UNITED STATES	5. LEASE
DEPARTMENT OF THE INTERIOR	NOO-C-14-20-5790 = 455
GEOLOGICAL SURVEY	6. IF INDIAN, ALLOTTEE OR TRIBE NAME
	NAVAJO ALLOTTED &
SUNDRY NOTICES AND REPORTS ON WELLS	7. UNIT AGREEMENT NAMES
(Do not use this form for proposals to drill or to deepen or plug back to a different reservoir. Use Form 9–331–C for such proposals.)	bet the state of t
reservoir. Use Form 9–331–C for such proposals.)	8. FARM OR LEASE NAME 5 2 5 5 5 5 5 5 5 5 5 5 5 5 5 5 5 5 5

1. oil gas other	DOME NAVAJO 13-20-5
2. NAME OF OPERATOR	1 2 2 2 2 2 2 2 2 2 2 2 2 2 2 2 2 2 2 2
DOME PETROLEUM CORPORATION 3. ADDRESS OF OPERATOR 501 Airport Drive	10. FIELD OR WILDCAT NAME WILDCAT

16. CHECK APPROPRIATE BOX TO INDICATE NATURE OF NOTICE,	#### F FAI#
REPORT, OR OTHER DATA	15. ELEVATIONS (SHOW DE KDB, AND WD)
REQUEST FOR APPROVAL TO: SUBSEQUENT REPORT OF:	6736' GR 5 2 2 2 2 2 2 2 2 2 2 2 2 2 2 2 2 2 2
TEST WATER SHUT-OFF	
FRACTURE TREAT	CEIVED and a property of the control
SHOOT OR ACIDIZE	
REPAIR WELL PULL OR ALTER CASING	(NOTE: Report results of multiple completion or zone
MULTIPLE COMPLETE	
CHANGE ZONES U. S. GEO	OLOGICAL SURVEY THE
ABANDON* (other) ADDITIONS TO APD	OLOGICAL SURVEY I bane to bank
	9 <

STANDARD BLOWOUT PREVENTER ASSEMBLY 900 SERIES

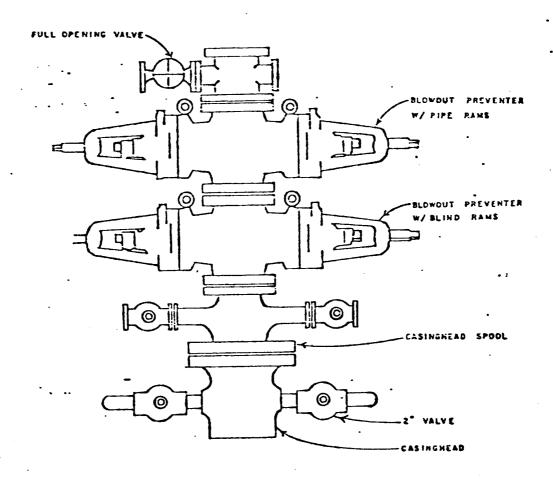
1. A schematic diagram of the BOP equipmen	t showing street APT series as
attached. BOP will be tested to 500 ps	
surface pipe. Pipe rams will be operat	
rams will be checked on trips.	1
